Re: PLN 2014-00410 Parrott Drive Subdivision

Re: Agenda Item #2, August 25th, 2021, File No. PLN2014-00410
August 24, 2021

By Dr. Gary Trott, Ph.D.

Re: Item #2 on the August 15, 2021 Agenda: File No. PLN 2014-00410; Z Enterprises LP, Owner, Steve and Nicholas Zmay, Applicants

Polhemus landslide, during 3rd heavy winter rain season 1997/98

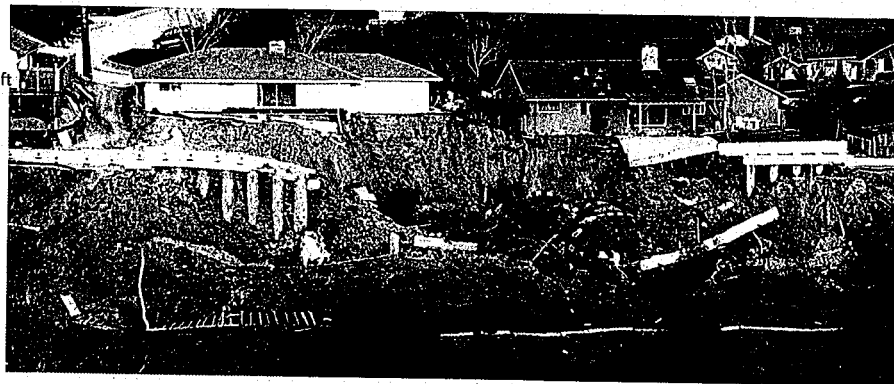
➤ Failures are not due to lack of good engineering, but lack proper engineering for *risk analysis and mitigation*.

- i) Followed "Industry GeoTech Standards"
- ii) Piers 3ft diameter and ~depth 30ft
- iii) Bore holes had water**
- ** red flag warning
- All are same as Parrott Dr. Design
- iv) \$25M dollars of damage

- Piers did not break
- Piers slid or tipped over
- Pier bottoms were *not* in "bedrock"

Conclusion: I) Design assumption of "bedrock" for stable pier foundation is *False*. Not valid.

Parrott Dr. site hydrology

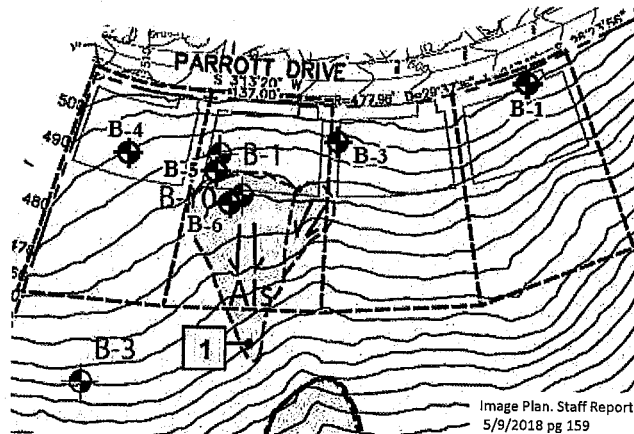
Ground water does not stop at uphill parcel boundaries. Found deep in bore holes

- No ground water table on a hill side. Why is there water greater than 20ft down? ** Red Flag??
- Parrot Pier depths 20ft -34ft** depending upon Civil Engineer (Same as Polhemus) Water is at bottom of piers

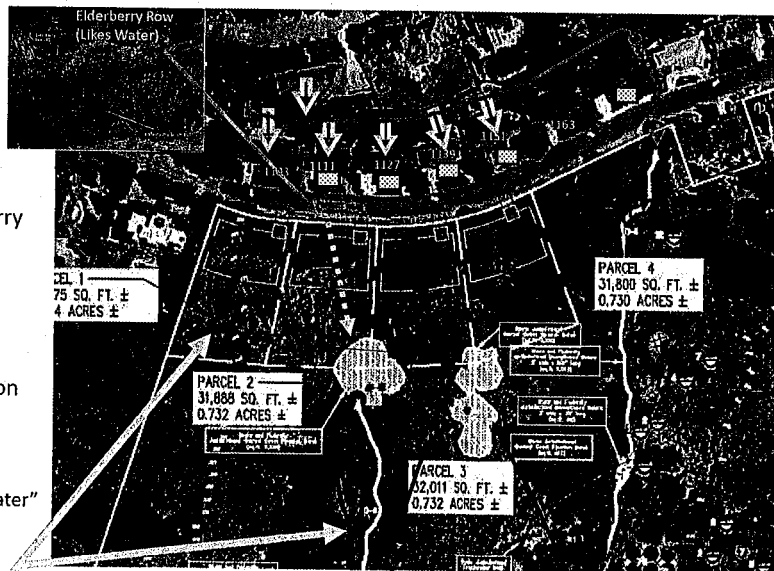
→ Federal protected, **Wetlands**
Water in bore holes + Elderberry bushes verifies, wetlands are fed from ground water flow along natural swales

→ And flow is increasing. The old 1950's Hillsborough subdivision drainage P.U.E. ditch is plugged (Orange)

Water flow dismissed as "nuisance water" from irrigation, leaky pipes, & street storm water.

Hydrology induced slides

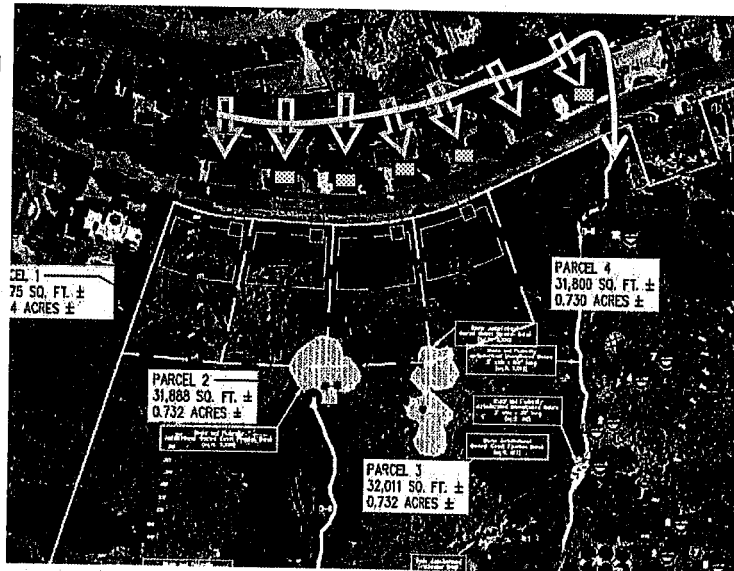
Actually ground water injection shown in blue and old landslide extent.

Seven new surface landslides due to water flow

Storm water no longer goes around. Injection by dry wells shown in blue

Slide Repair Civil 3/10/2018 Two stitched pier walls

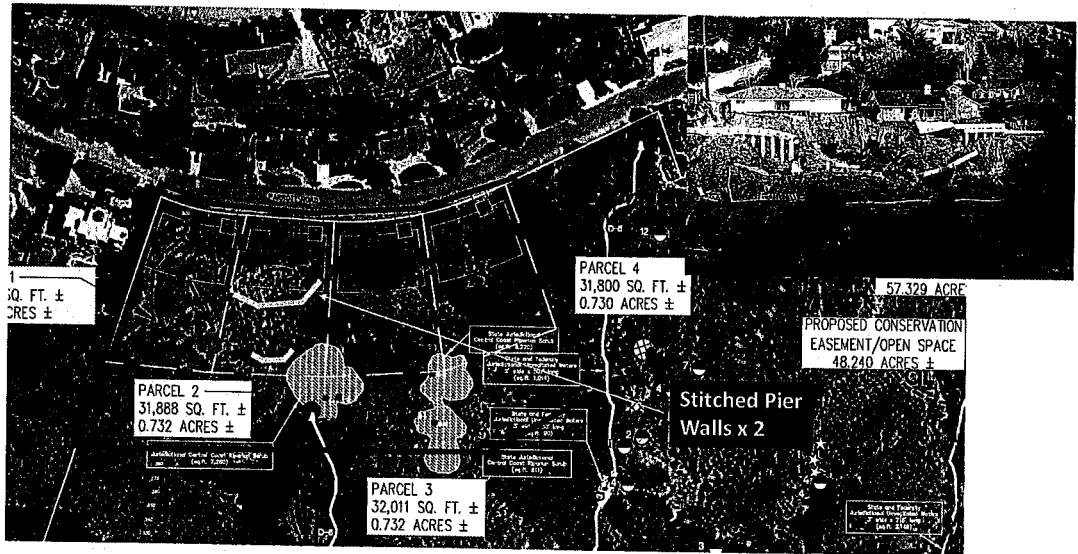
Murry Eng 9.28.2018 Supplemental stitched pier walls. "Please note minimum recommendations . . . No warranty"

Parcel # 1

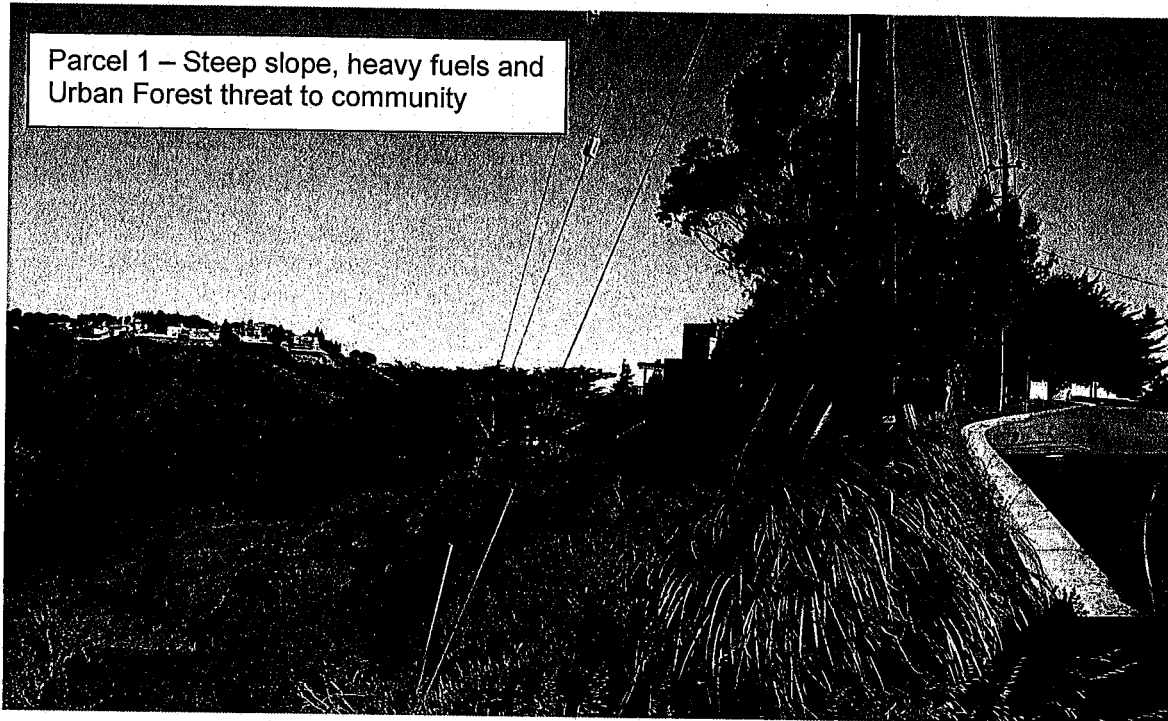
Condition: The native plant communities are over-mature and have subcanopies of fine dead material that ignites easily and burns intensely. In the 1995 "Vision Fire" the fire spread went 11,000 acres in as many hours.

Conclusions: The development of this parcel is putting people and property in harm's way and it exacerbates the fire risk to the east of Parrott Drive community.

Recommendation: The Fire Marshal should be consulted about the proposed development of this parcel.
